Agenda
Village of Arlington Heights
Zoning Board of Appeals
Virtual Meeting

March 15, 2021
7:00 PM

Item: 406 N Waterman Ave - ZBA#21-008

Prepared By: Derek Mach, Planner
Hearing Date: March 15, 2021
Date Prepared: March 10, 2021
Project Title: Gonke Residence
Address: 406 N. Waterman Ave.

SHEET TITLE
ELEVATIONS

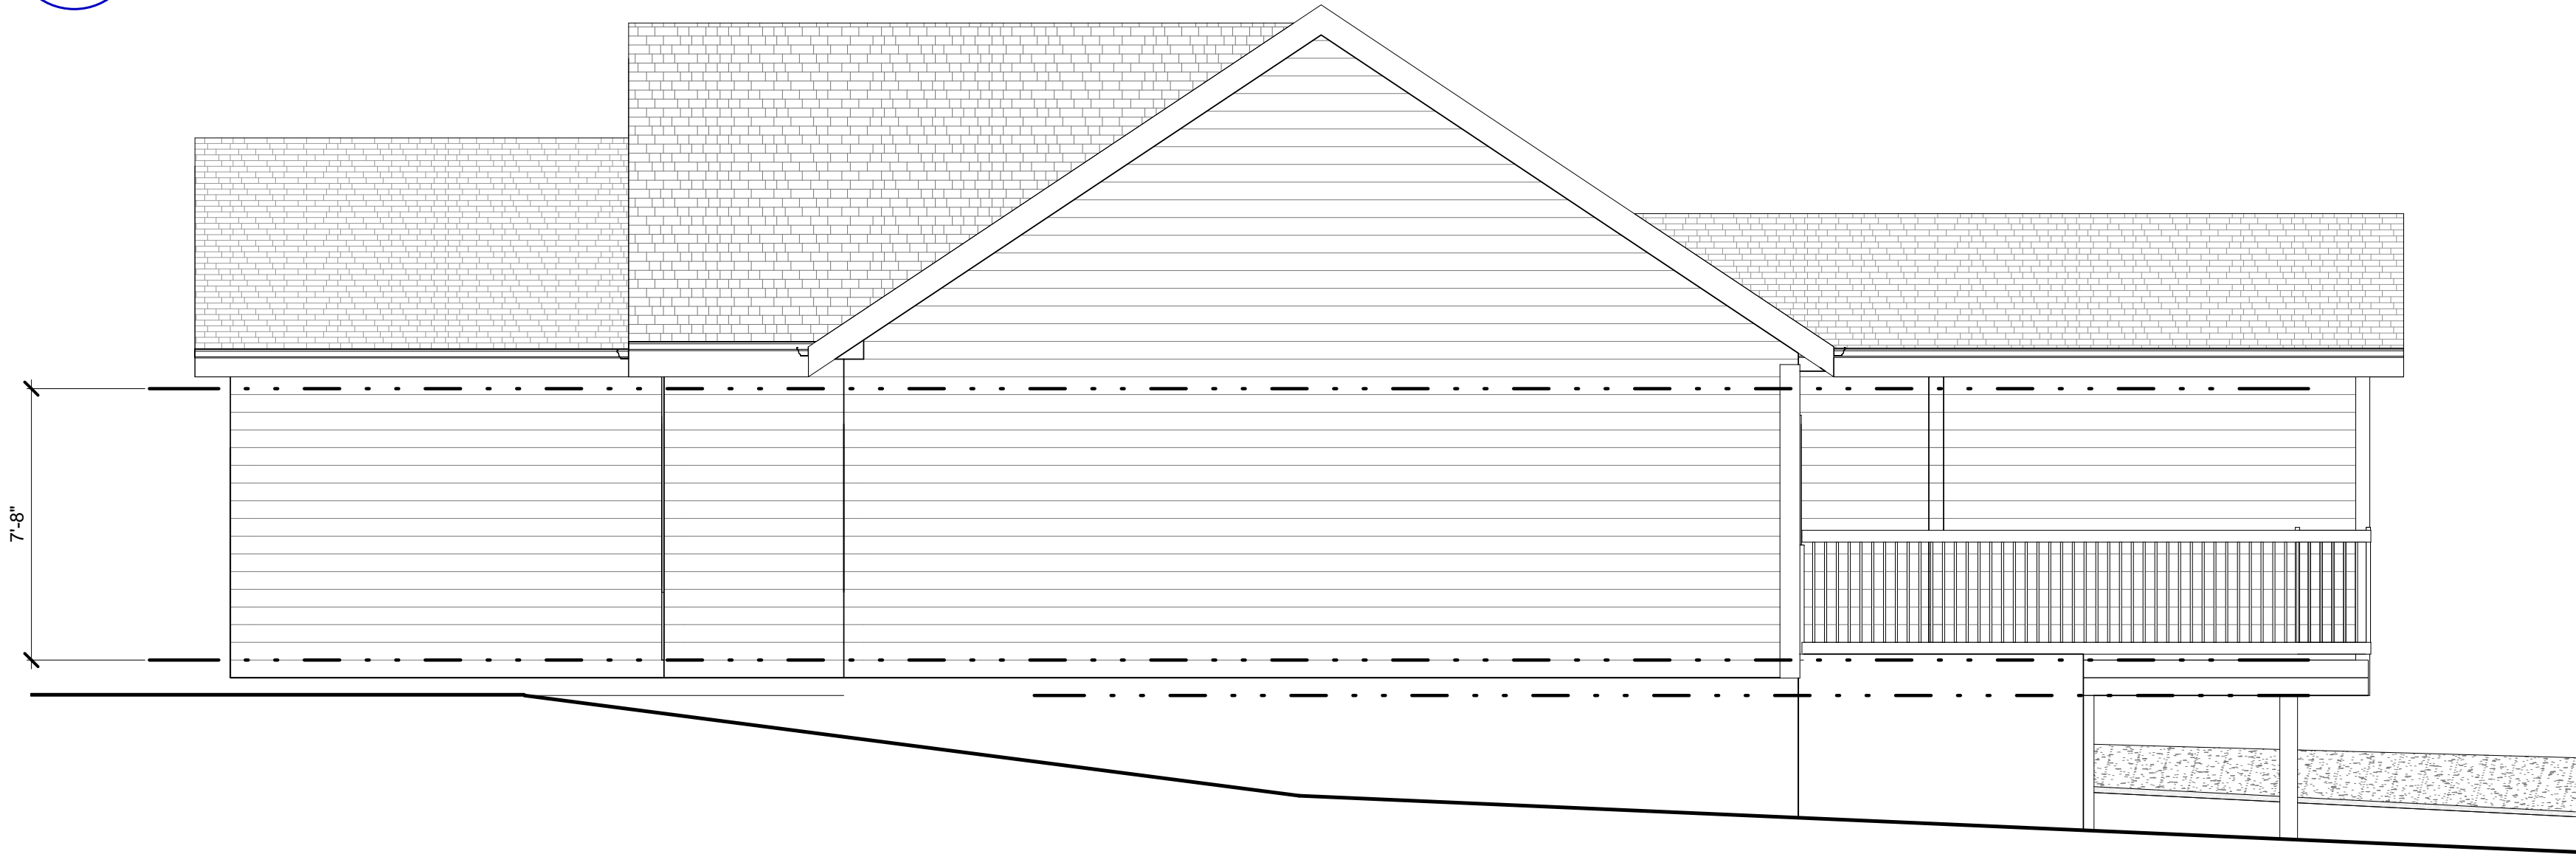
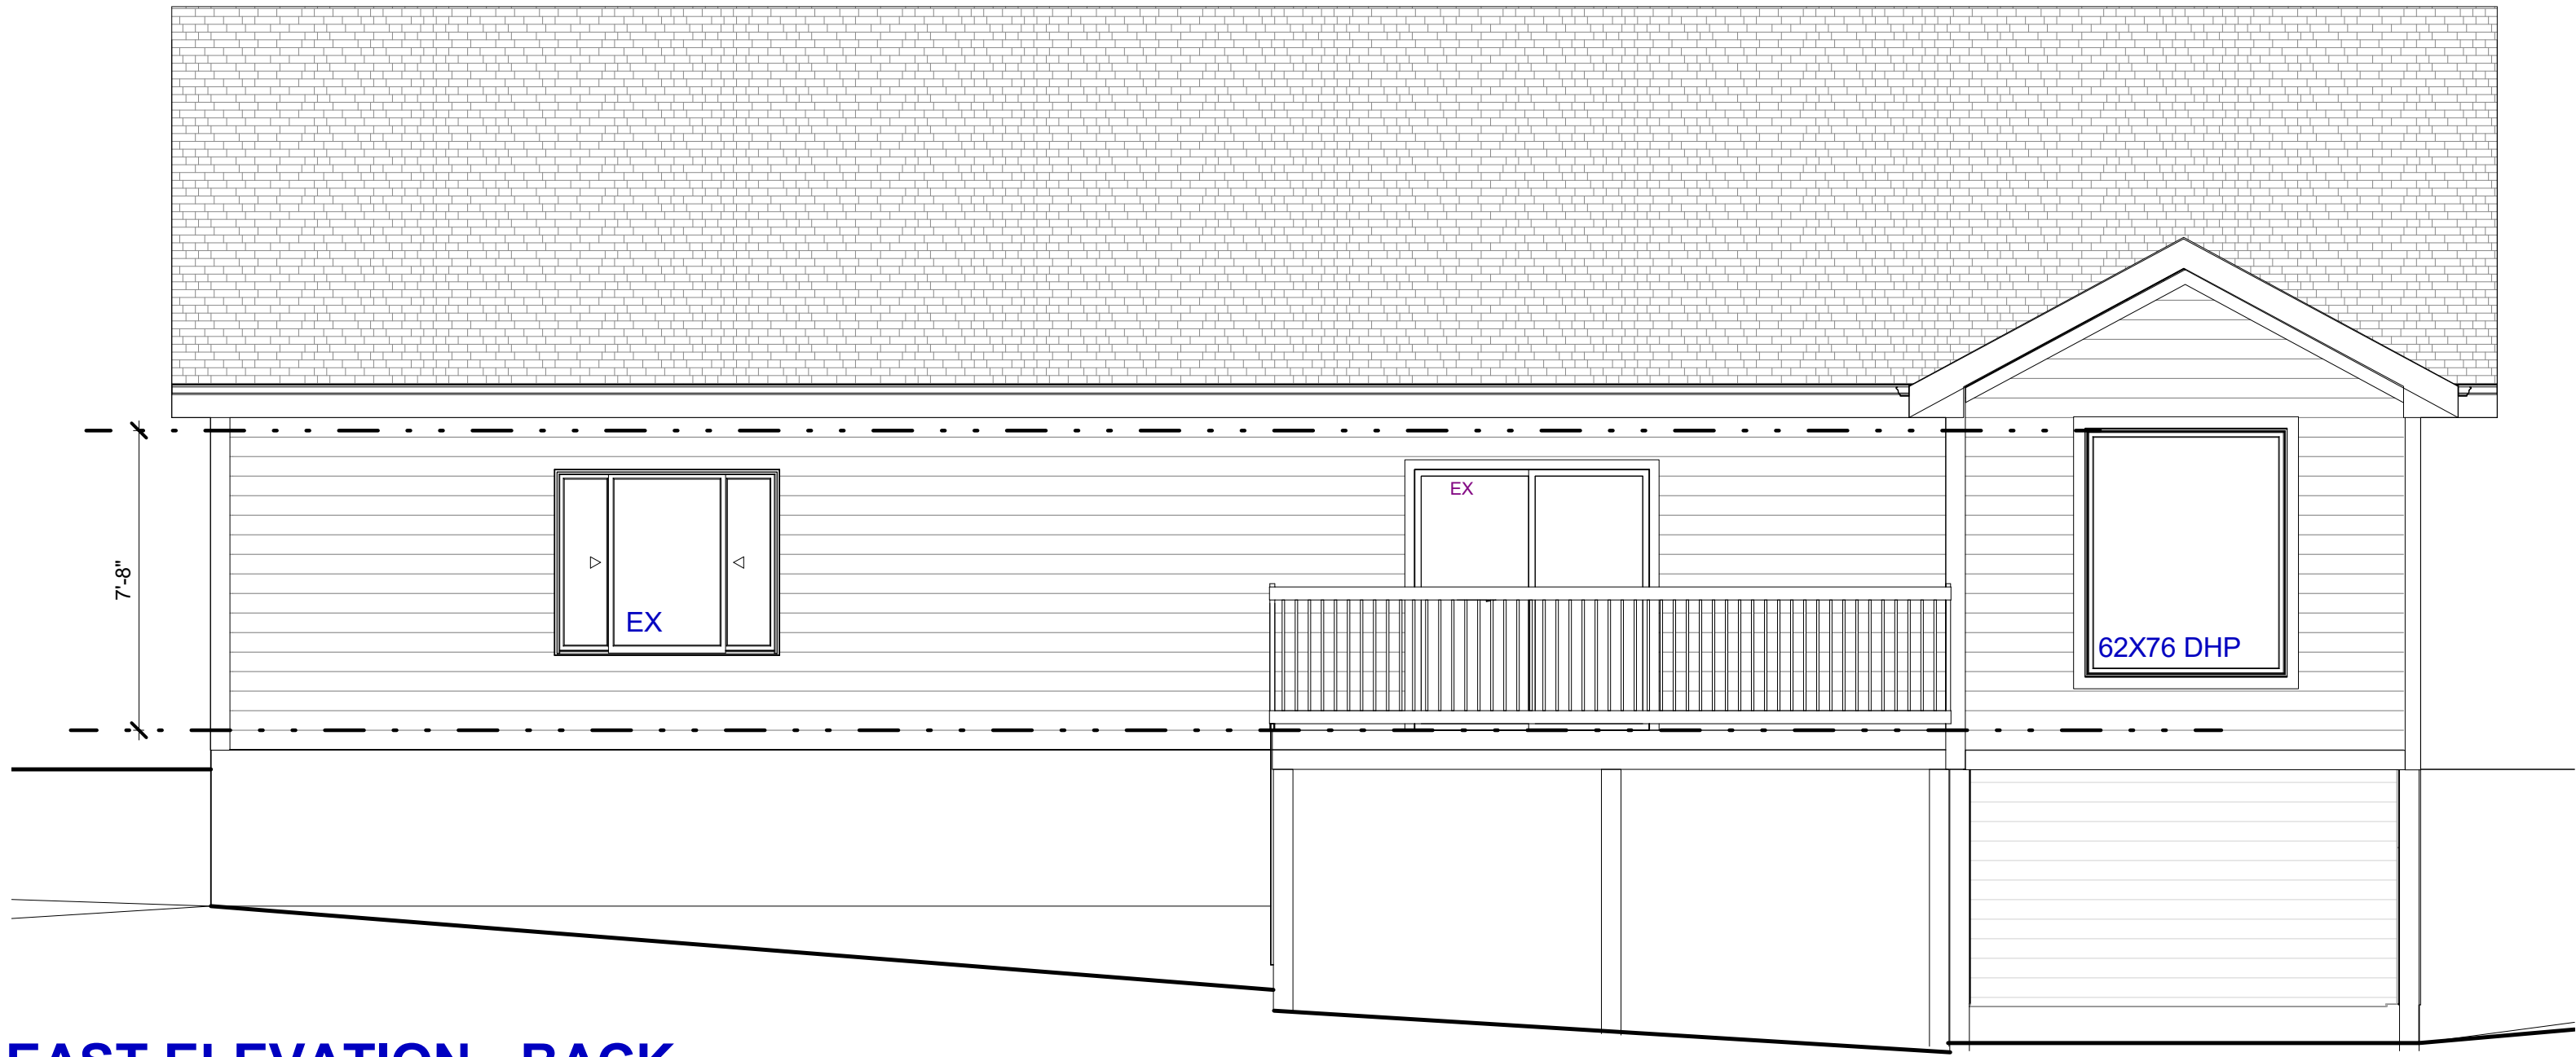
Note: A trench foundation will be required for the addition. The 2018 International Residential Code section allowing pier foundations, R404.1.5.3, as shown on the proposed elevation was removed and not replaced during the most recent code adoption in March of 2020.
